**ALAMEDA COUNTY COMMUNITY DEVELOPMENT AGENCY  
PLANNING DEPARTMENT**

**STAFF REPORT**

**APPLICATION TYPE AND NUMBER:** Ministerial Project Review Permit for PLN2019-00167

**PROPOSAL:** Under California Government Code Section 65913.4 (also known as Senate Bill 35 (SB 35)), and State Density Bonus Law Government Code Section 65915: affordable residential mixed-use development to include a seven-story building, 79 deed-restricted affordable housing units, 9,700 sq. ft. of public meeting facility on the ground and second floors, and 2,900 sq. ft. of day care on the second floor.

CO.0

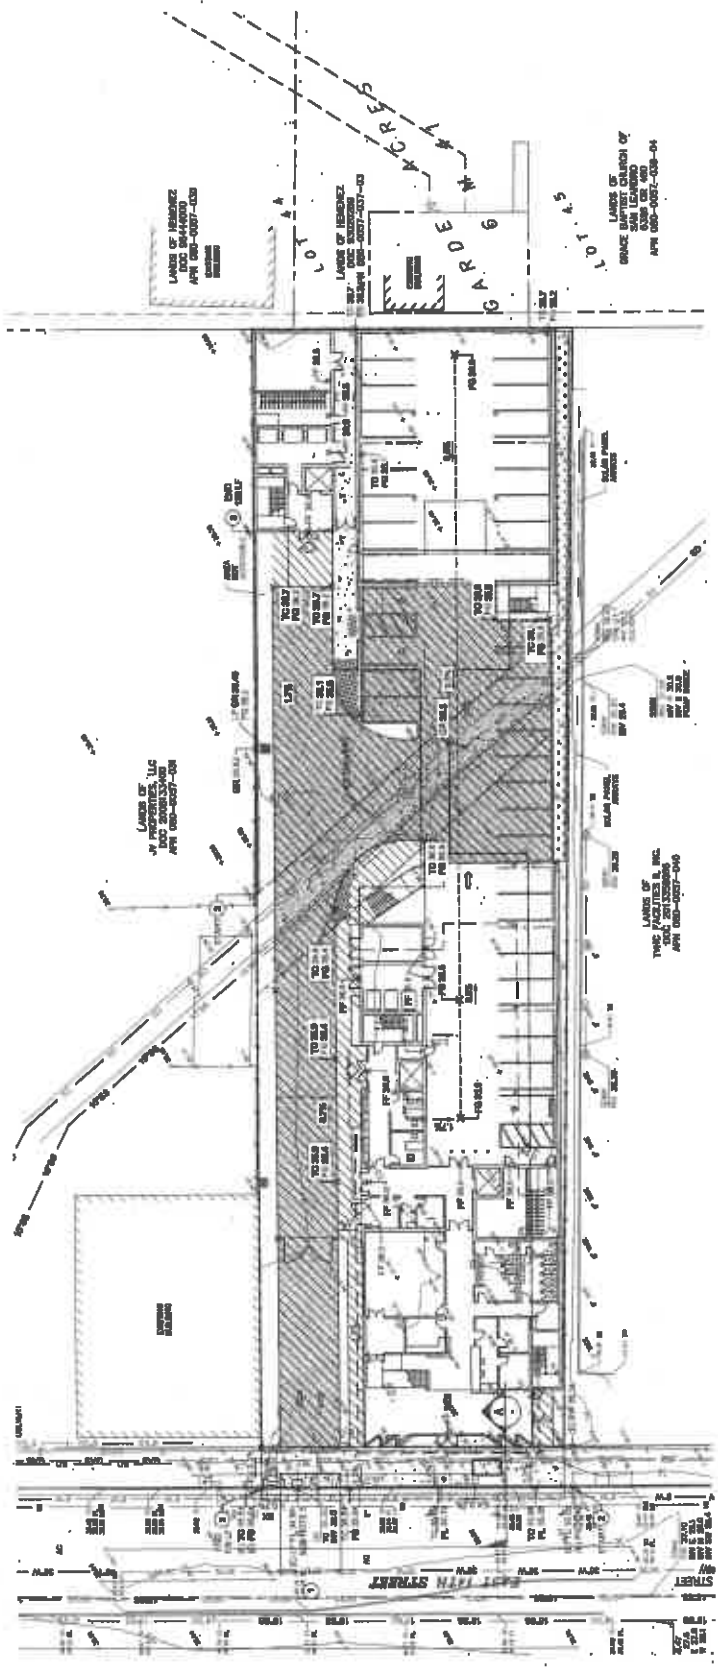
6. Per C0.1, there appears to be an existing manhole/inlet over the District culvert in the middle of the site. The inlet part, which I assume means a manhole cover with slots or holes, will have to be replaced with a solid cover – but there could be a question of why the new system is not being connected to the old manhole. **BKF Response: Existing inlet at culvert is to be replaced as a manhole cover, as noted on the plans.**

**C0.2**

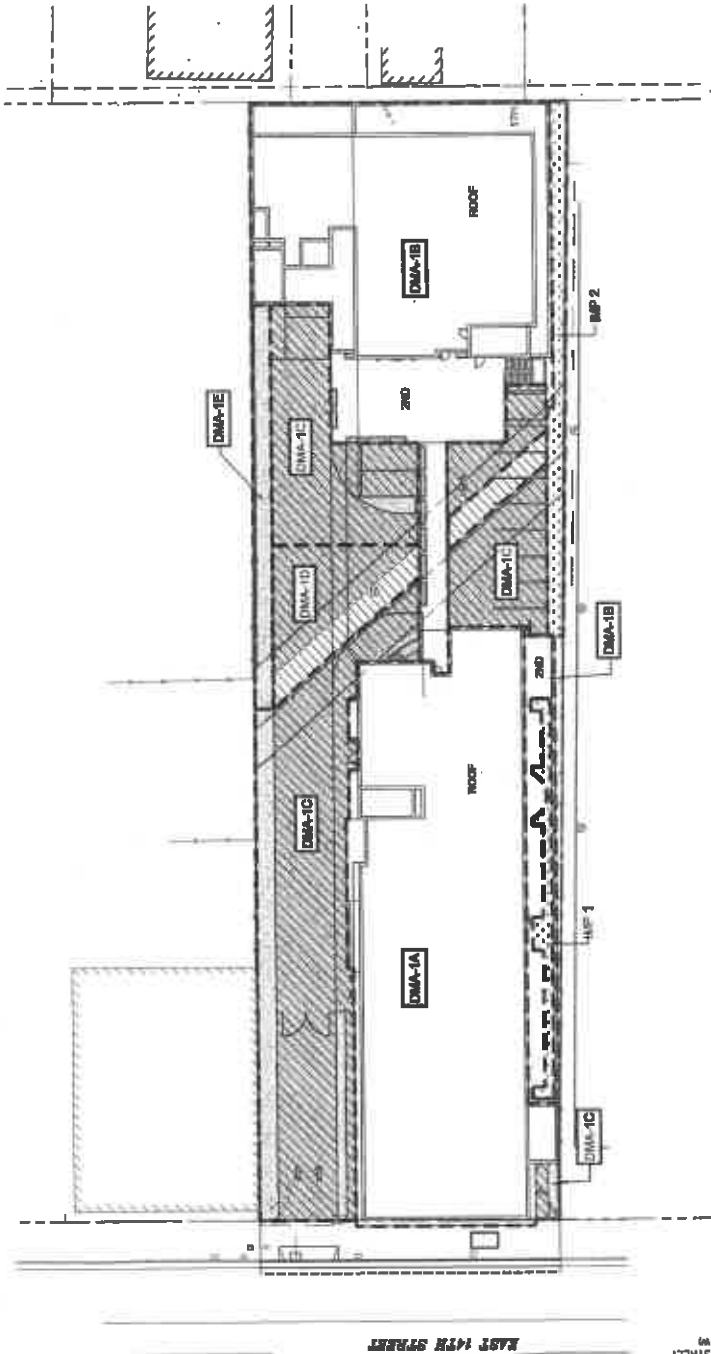
The proposed peak flow was calculated using the 2016 Alameda County Hydrology & Hydraulics Manual. See Sheet C0.2 for proposed site conditions. The following values for the Rational Method were determined:

**C0.4**

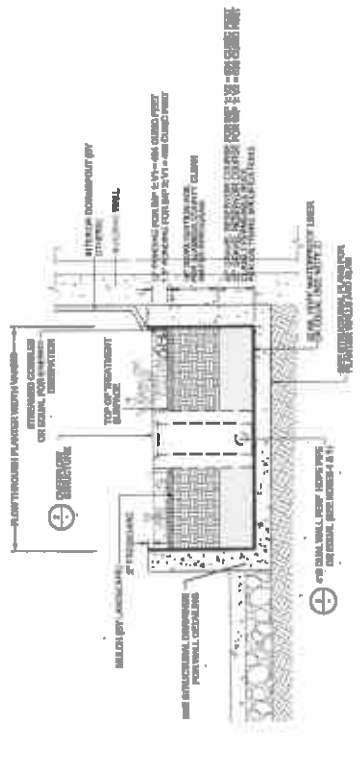
1. The drainage management plan on C0.4 is unusual, given that it seems to describe stormwater collection: at various levels of the buildings – and treatment measures not only on the ground next to one of the buildings, but also on the second floor of the other building. The obvious issues will be waterproofing the buildings and getting access for post-construction inspection, but we are also going to have plumbing system design issues related to getting runoff into these facilities, getting overflow and treated runoff out, and how high flows from major storms can bypass the treatment and drain away from the buildings and the adjacent properties. Treated water must be collected and discharged directly into the County stormdrain system, either the on-site culvert or the roadway culvert. Going to be a very interesting drainage system that we aren't going to fully comprehend until we see the building plans. **BKF Response: Once we reach the CD phase, MEP can confirm the viability of our Stormwater routing. For clarity, roof floor labels have been added to the Stormwater control plan. Planter access will be coordinated with the building owner. Entire site is to be treated with permeable paving or bioretentions, and the bioretention planters are sized appropriately to maintain existing runoff volume to the culvert.**

**A1.6**

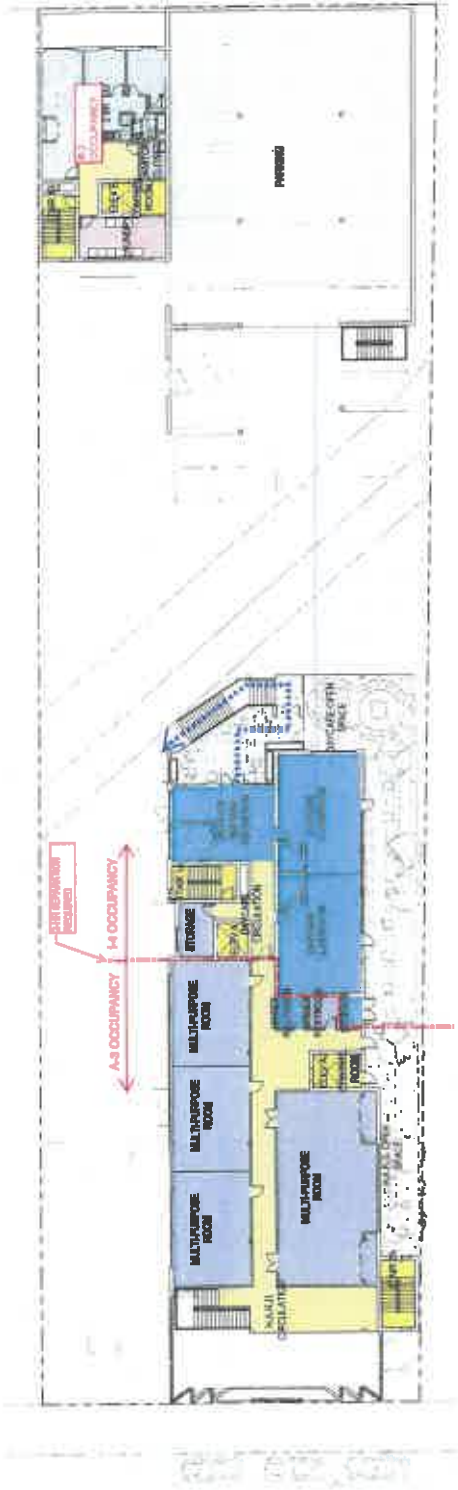
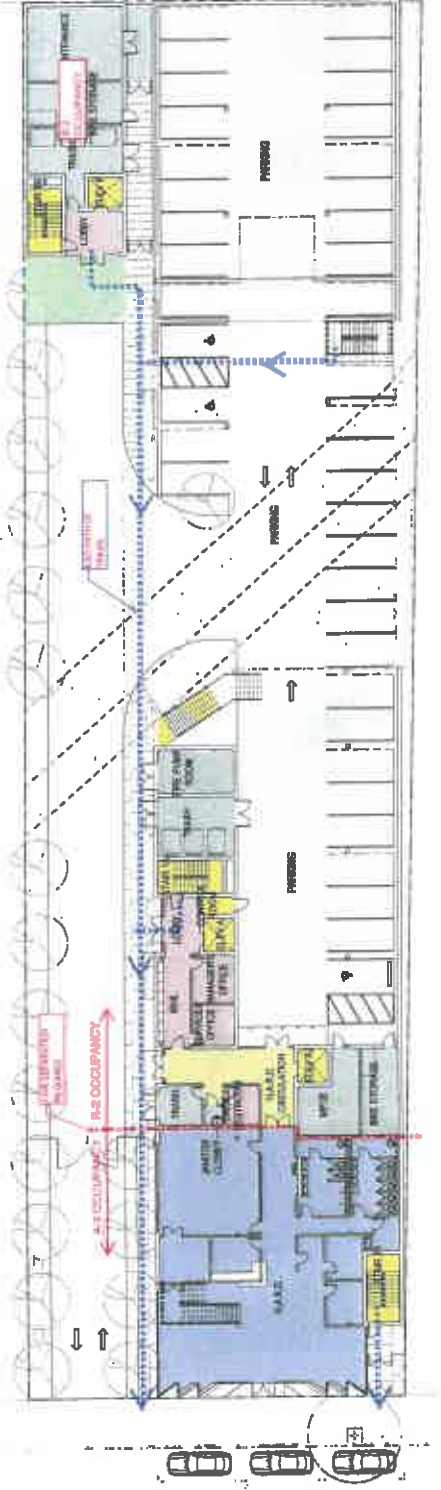
Based on summary above we can meet the minimum requirements of section 436.1 for I-4 daycare to be located above the 1<sup>st</sup> floor. See sheet A1.6 for additional notes.

**Response: see sheet A1.6 attached for occupancy types**

**Response: see sheet A1.6 for access to public right-of-way from building exits.**

**Response: see plan sheet A1.6 for identified use of each space and occupancy types.**

**Response: see sheet A1.6 for code references.**
